# Initial Project Review

## Preliminary Plat / Planned Development District / Rezone: Hollow Pointe Park

**Application Numbers: 921345, 921352, 921354, 921356**  
**Tax Parcel Numbers: 0320346003, 0320346004, 0320342061, 0320342062**

**Project Location:** 1308 - 85<sup>th</sup> Street East, Tacoma WA, within the NW 1/4 of Section 34, T20N, R3E, W.M., in Council District #5

# Proposed Preliminary Plat Site Plans

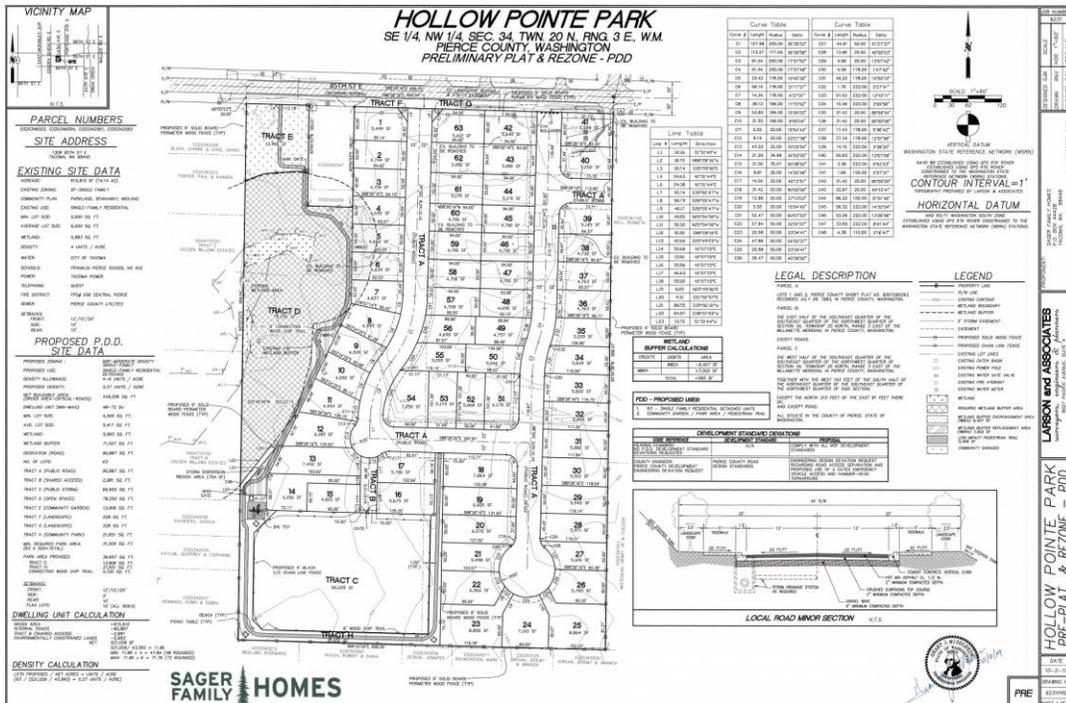
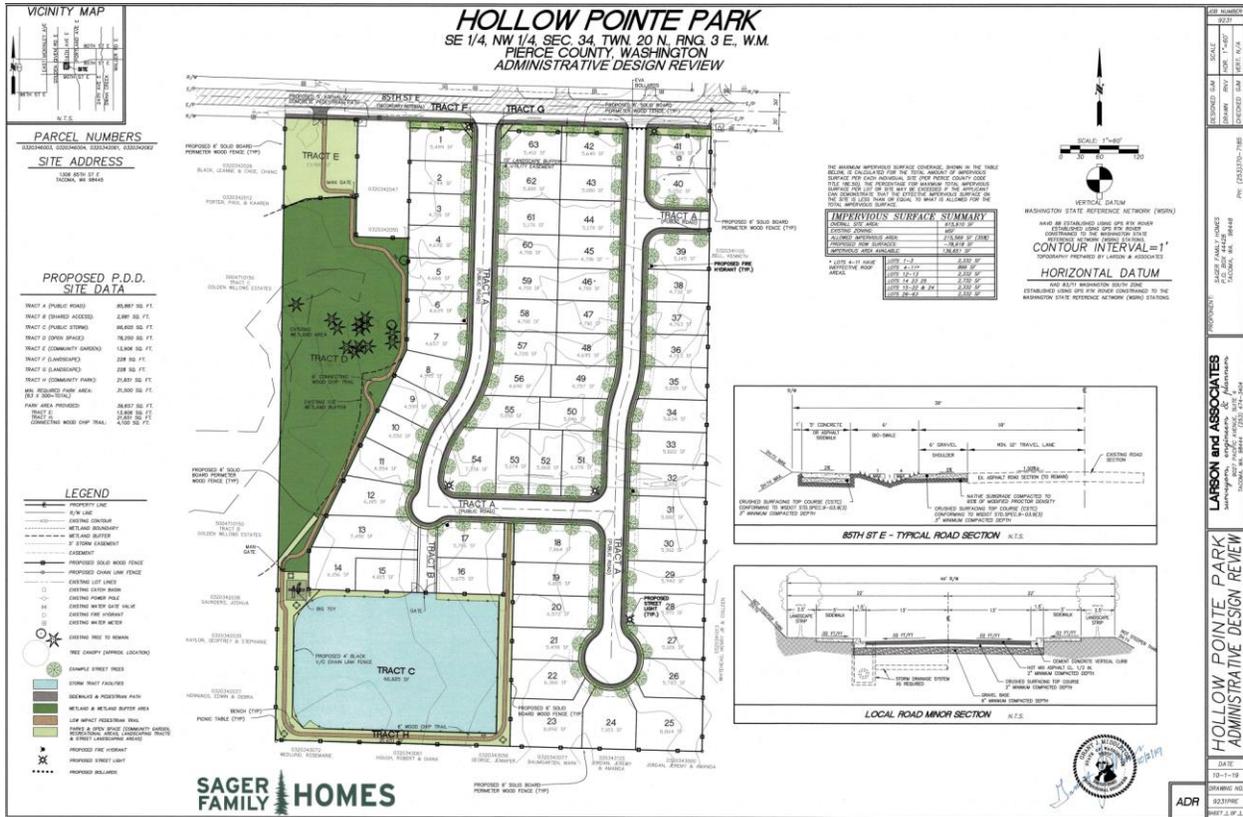
- Cartography Section of Planning and Public Works (PPW):
  - Street names are required.
- Development Engineering Section of PPW:
  - Development engineering has reviewed the preliminary plat and has requested an additional 5-feet of right-of-way along 85<sup>th</sup> Street East, and has provided the following red line comments: comments regarding the secondary emergency vehicle access onto 85<sup>th</sup> Street East, comments regarding the stub-out road to the neighboring east property, and requests a deviation to the application for the proposed cul-de-sac as a result to the plat being greater than 50 lots.

- Storm drainage is being proposed to be handled through an infiltration storm drainage tract (Tract C) located in the southwestern portion of the plat.

## Landscape Plan

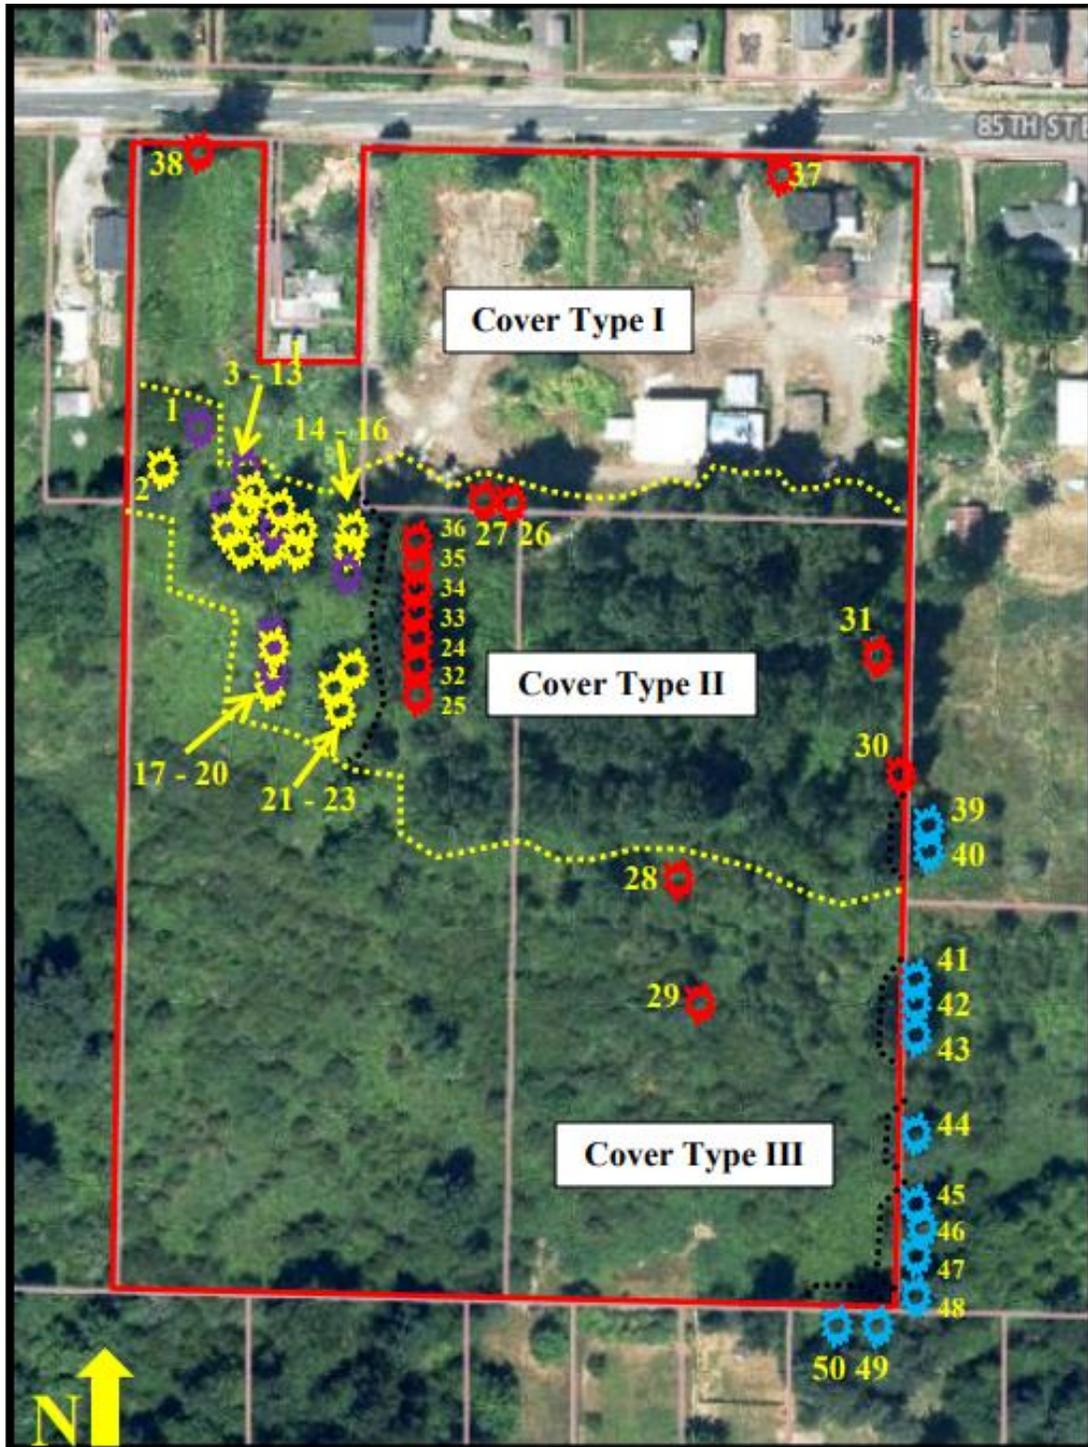
- Street trees will be provided internally along the new roadways at 1 per 30 lineal feet of frontage of tracts and a minimum of 1 street tree per lot will be required on the plat roads prior to home occupancy; 85<sup>th</sup> Avenue East is considered an arterial road, therefore a Level 3 landscape buffer will be required along 85<sup>th</sup> Avenue East.
